**RE: Town of Kittery, Planning Board Services
Site Plan Review #2
Rice Public Library (8 Wentworth Street) Tax Map 4, Lot 88
CMA #591.132**

Final Site Plan Review Application

Rice Public Library Expansion

Final Site Plan Review Application
Rice Public Library, 8 Wentworth Street

RICE LIBRARY LOGISTICS PLAN 9/11/2020

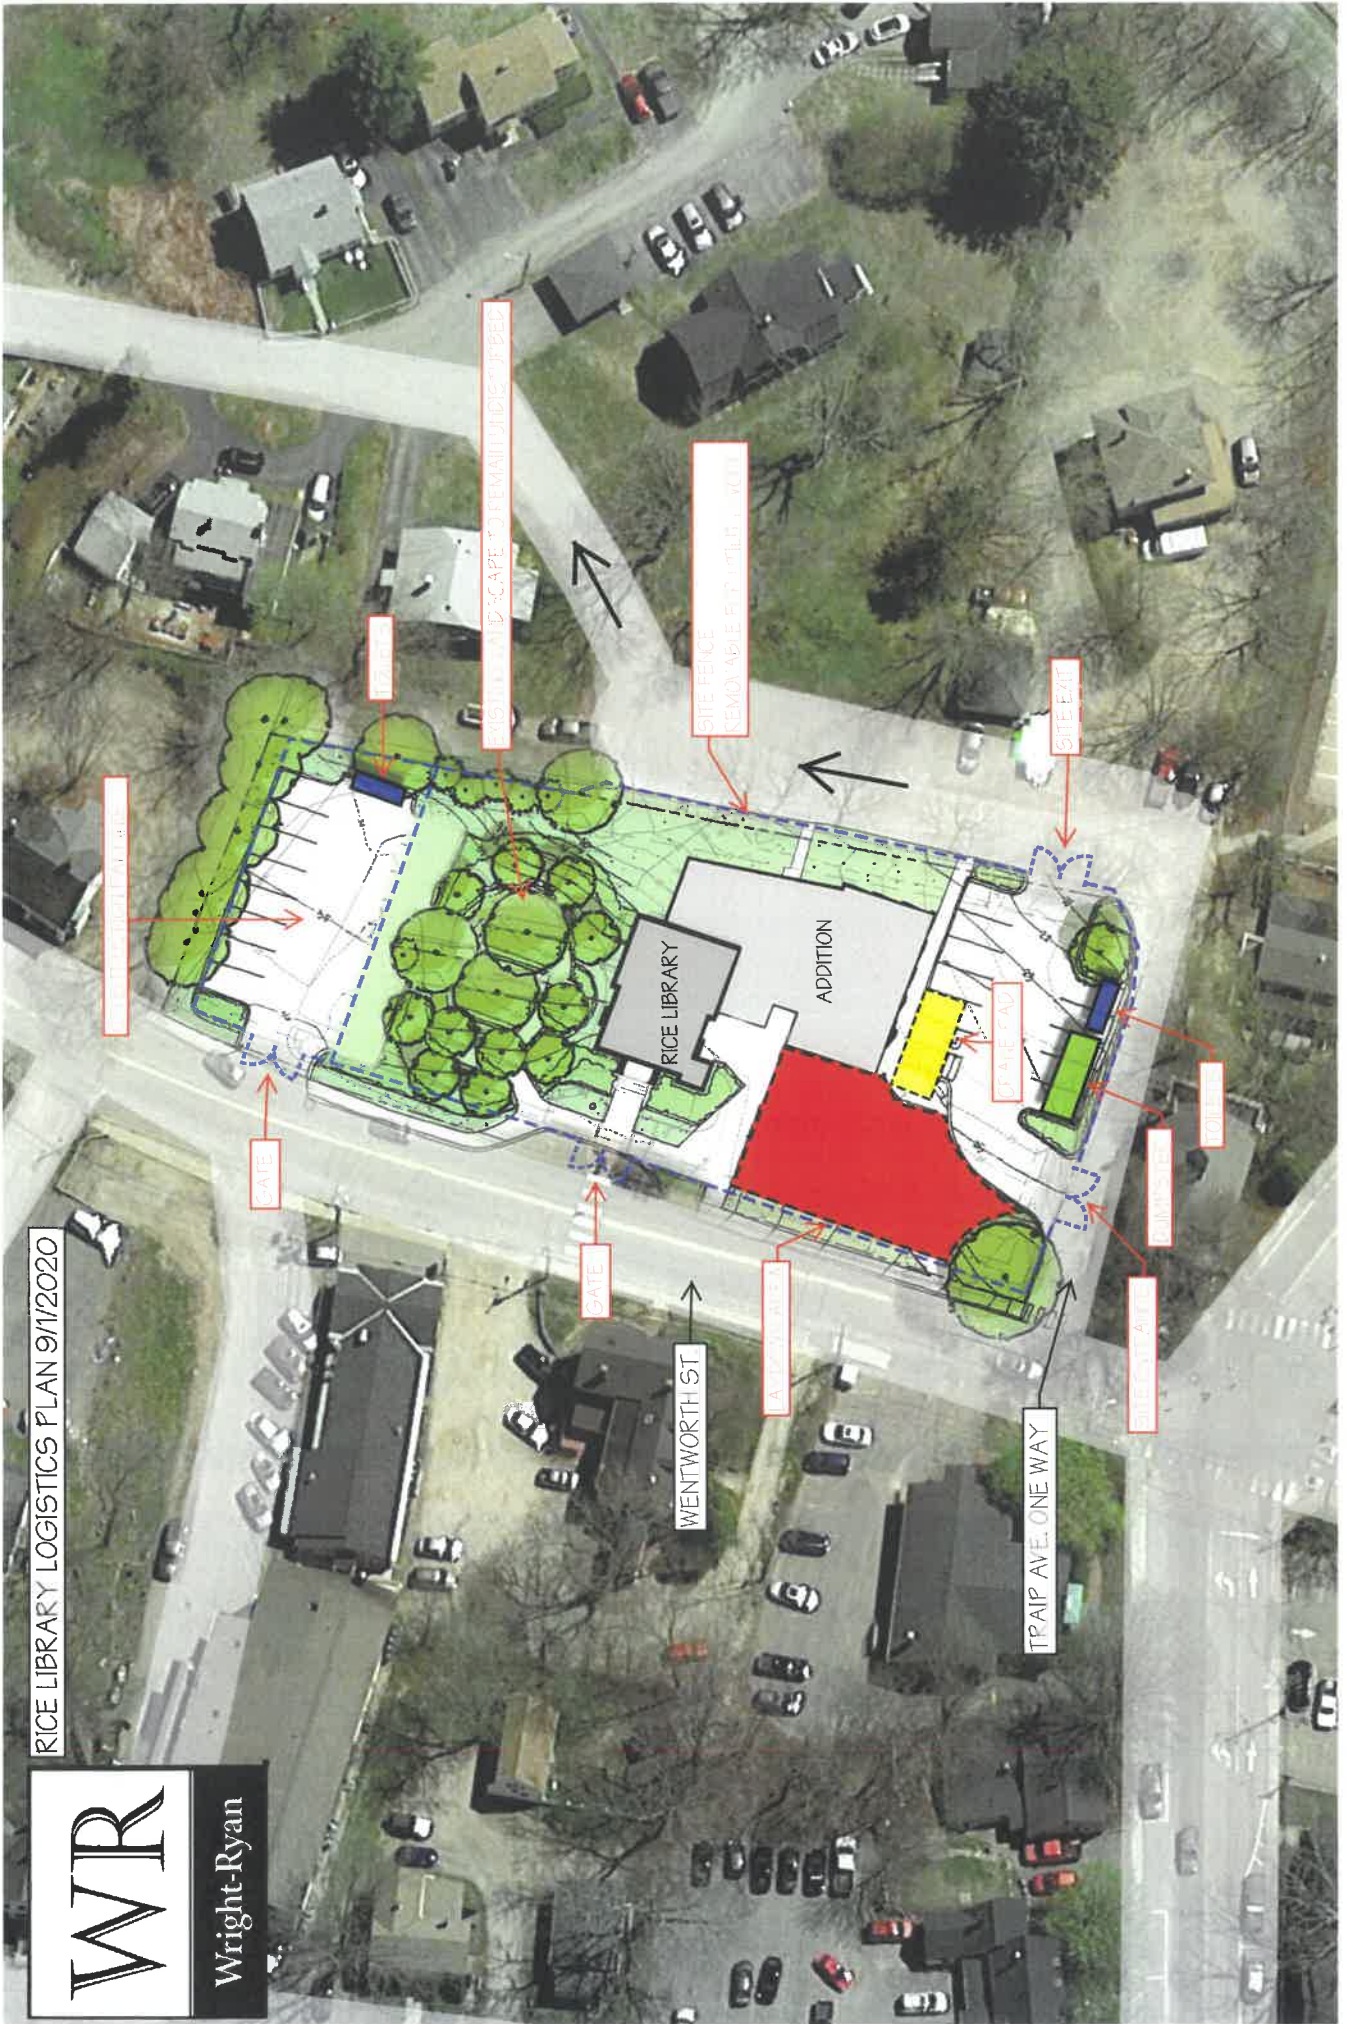
9. *While an erosion control plan is provided by the Applicant there appears a construction sequencing plan has not been furnished. The Applicant should provide a construction sequencing plan to the Board for review and approval.*

A Construction Logistics/Staging plan is included.

SHEET 1 OF 1

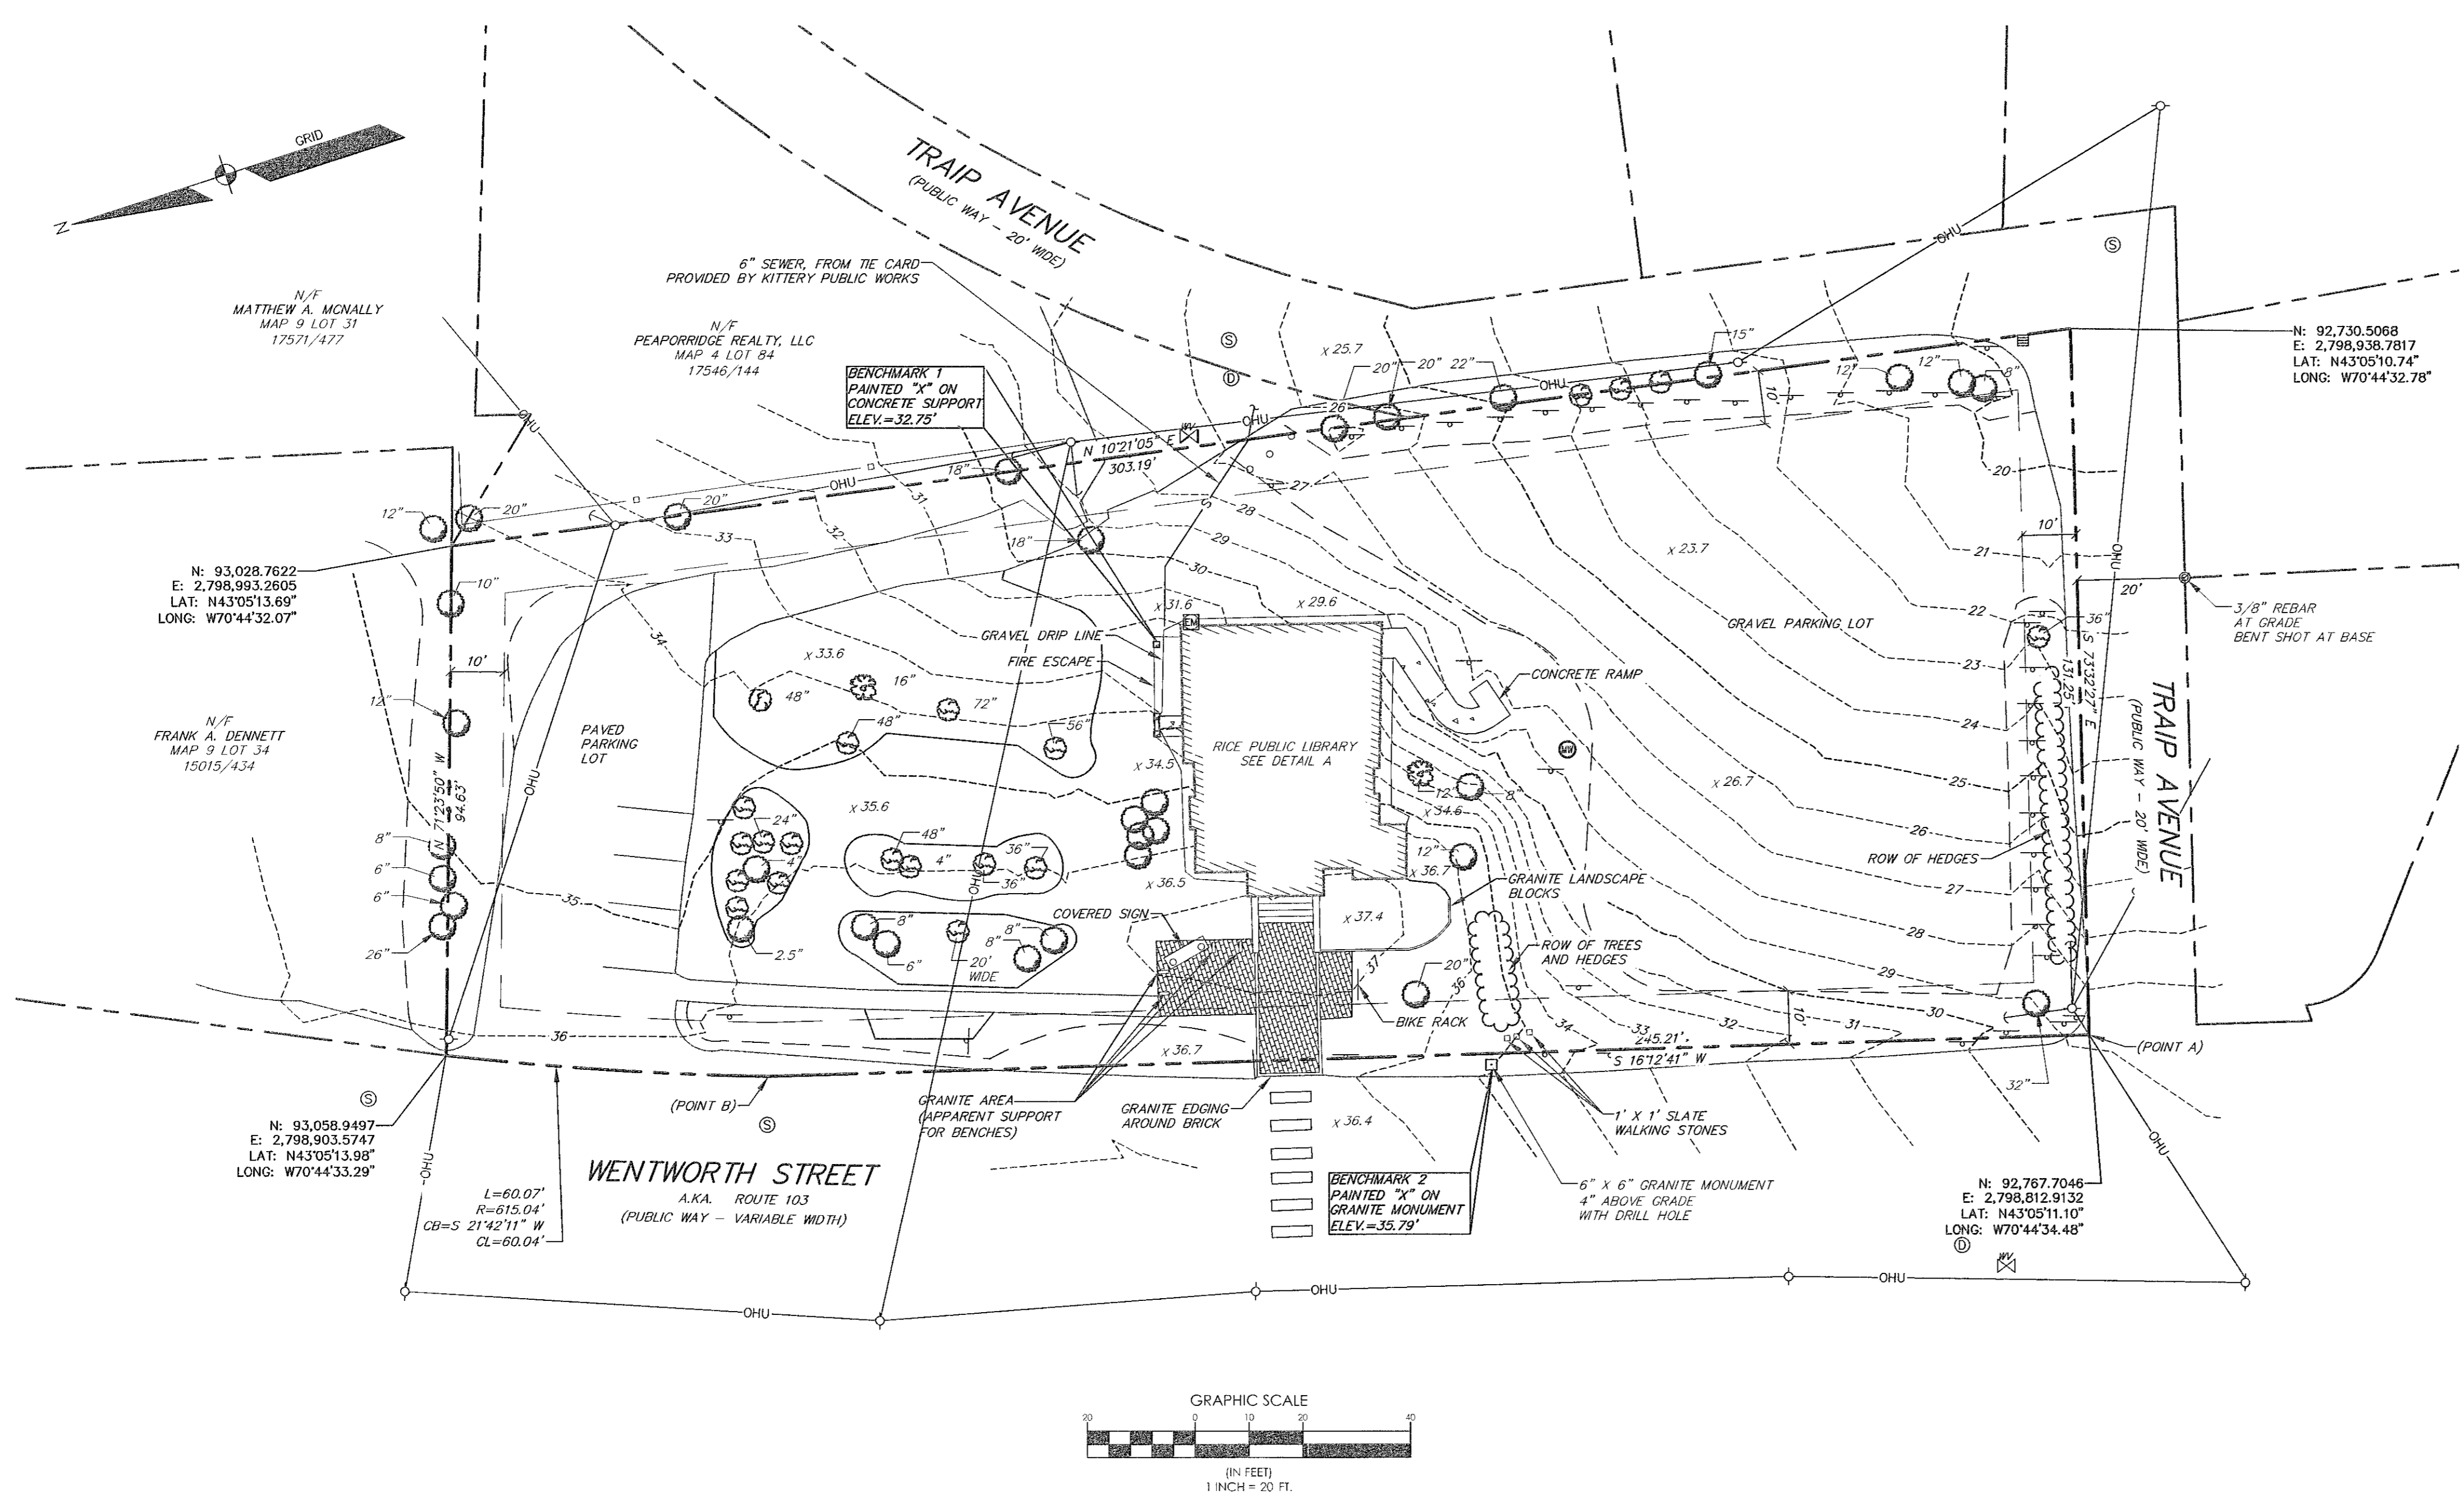
8. *The "Surveyor's Statement" on Sheet 1 of 1 needs endorsement.*

This endorsement is included in the attached plan set.
